I am currently reviewing BC&D Operating's application of West Jal Deep SWD No.6 and had a few questions.

West Jal Deep SWD #6

From: Richard Hill <rhill@wellconsultant.com>
Sent: Thursday, May 21, 2020 10:01 AM
To: Garcia, John A, EMNRD
Subject: [EXT] RE: West Jal Deep SWD No.6
Attachments: West Jal Deep #6 SWD C-108 AMENDED PAGES.pdf

West Jal Deep SWD #6

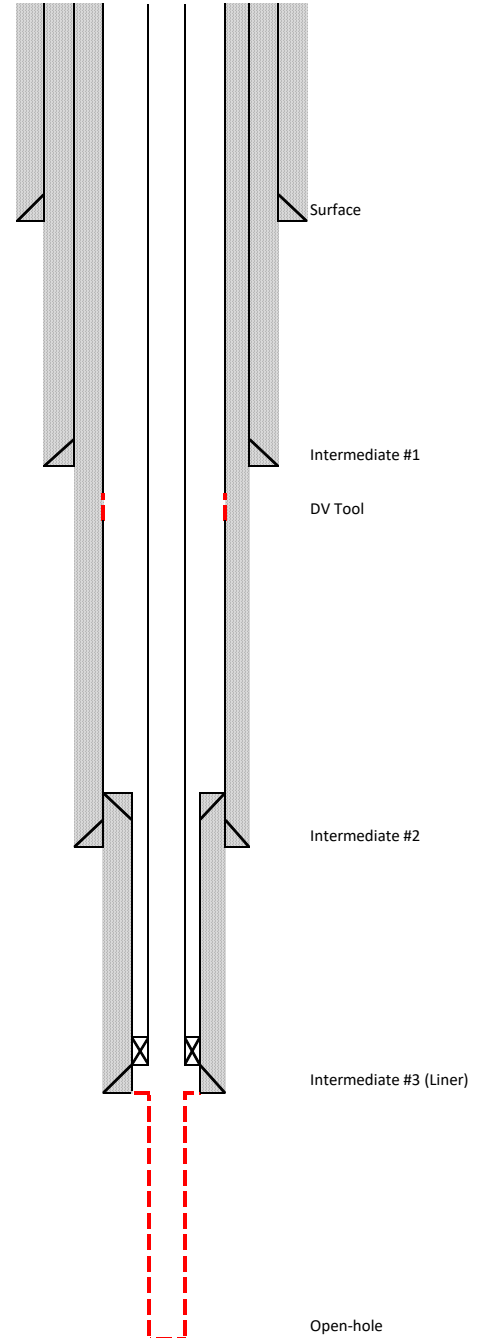
I have a question in regard to the additional information you had sent in. You had resubmitted a table which has the geological depths. However this table had different tops for the Devonian then the original application. Which one is accurate? What information lead to a change of 13'? both tables are below

1. The injection interval is listed as 14,544' to 17,100' while the open hole ranges from 15,250' to 17,100'. Can you explain why the injection interval is listed at approximately 700 ft larger than the open hole interval?
2. Target formations are listed as Mississippian – Devonian – Fusselman – Montoya. However, the division currently does not allow injection into the Mississippian – Woodford – Montoya. These formations will need to be excluded from the injection interval. Please submit the necessarily corrected information to mend this. (Also this will need to be reflected in the injection interval depths)

Sorry for the late response... I think the original application was a typo, when I made the correction I adjusted it based on the casing design. However the Dev top will be determined off mud logs and e-logs. My well bore design only works if the 7" casing is set into the top of the Dev, it would be a economic failure to not cover the entire Woodford shale with casing. In this particular area the Woodford and Miss are extremely tight and will not take water, they would only lead to hole stability issues if left uncased. I hope this helps and I will look deeper into this matter Monday morning.

Thank you for the email, and I'm sorry about the confusion. We plan to set 7" casing in the top of the Dev, so the Woodford and Mississippian will be covered. We never had intentions of perforating the 700' in your first question; we were requesting it to give us room to adjust the packer setting depth in case of future issues. That is an easy fix, and we can cut the 700' off and only ask for the open hole interval.

Hole Size 6"
Casing 7" - 32# P-110HC BTC SpCL Casing
Depth Top: 15250'
Depth Bottom: 17100'
Inj Interval: 15250' - 17100' (Open-Hole Completion)
